Access Compliance Report

Public Rights-of-Way

(Curb Ramps)

| Intersection ID: 10022801 | Main Street: CASCADE_POINTE_BV | Cross Street: N/A | Location: SW |

| ADA ID: 4FDD7DDF293F | Ramp Type: Combination1Diag | Initial Pass/Fail: Fail | Overall Compliance: No |

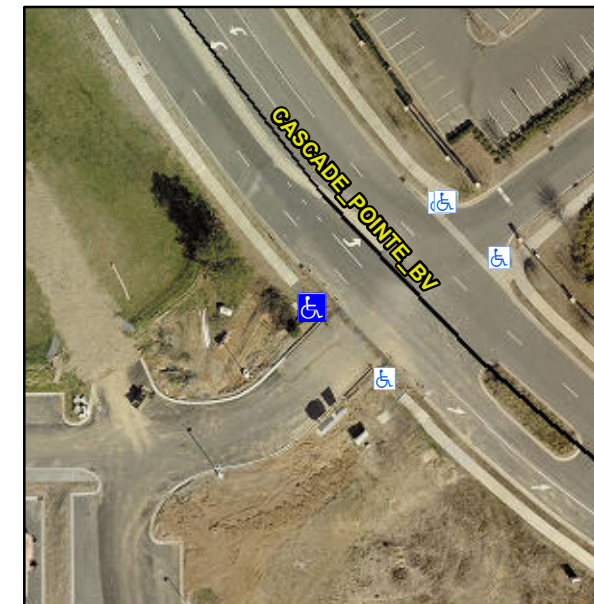
CONSTRUCTION, RT RP < 5%

R304.3.2

| Compliance | Description | Data | Compliance | Description | Data |
|------------|--------------------------|-------|------------|-----------------------------|------|
| No | Ramp Slope LT (%) | 9.5 | Yes | Ramp Slope RT (%) | 2.8 |

Remove & Replace Curb Ramp With Two New Directional Ramps or Equivalent.
